# **VAX 6000 Model 200/300/400 Processor Console and Diagnostic ROM Upgrade Instructions**

**Revision/Update Information:**    Revision: V1.6, October 10, 1990

**Order Number:** EK-60ROM-UP-001

**Figure 1: KA62A and KA62B Processor Layout (T2011 Module)**

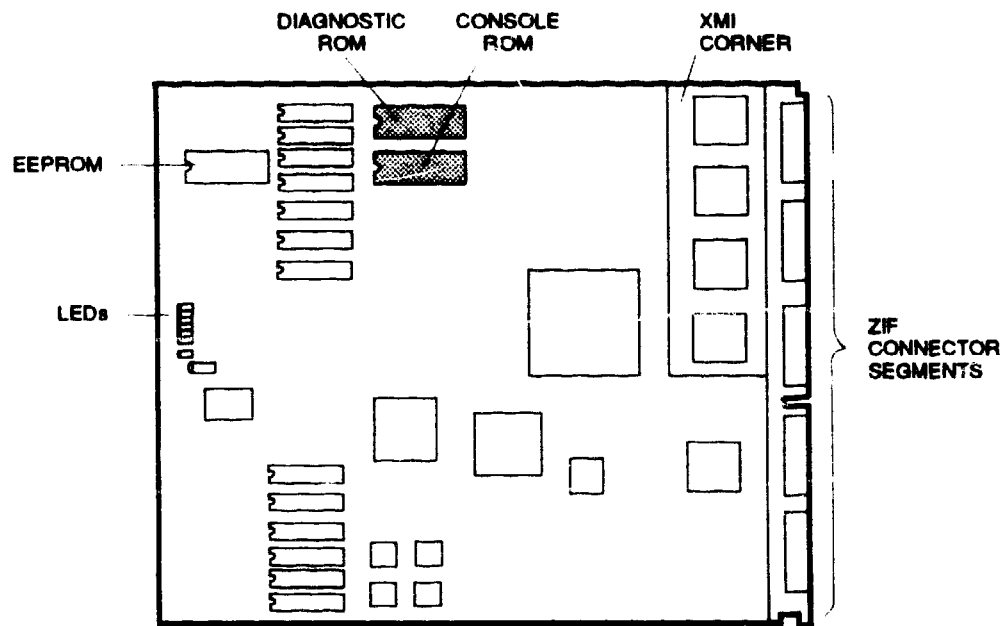
18. Remove a processor module from the card cage, handling it properly as you place it on the mat. Refer to Table 4 for the appropriate new ROM part number and Figure 1 or 2 for the location of the ROMs depending on model of processor.

- a. Remove the old diagnostic ROM and replace it with the new diagnostic ROM, being careful to align the chip leads before inserting the ROM into the socket.

- b. Remove the old console ROM and replace it with the new console ROM, being careful to align the chip leads before inserting the ROM into the socket.

Processor	Module	Loc	Console ROM	Loc	Diagnostic ROM
KA62A-AA	T2011-00	E16	23-186E9-00	E08	23-187E9-00
KA62B-AA	T2011-YA	E16	23-188E9-00	E08	23-189E9-00
KA62B-AB	T2011-YC	E16	23-192E9-00	E08	23-189E9-00
KA64A-AA	T2015-00	E97	23-190E9-00	E77	23-191E9-00
KA64A-AB	T2015-YA	E97	23-194E9-00	E77	23-191E9-00
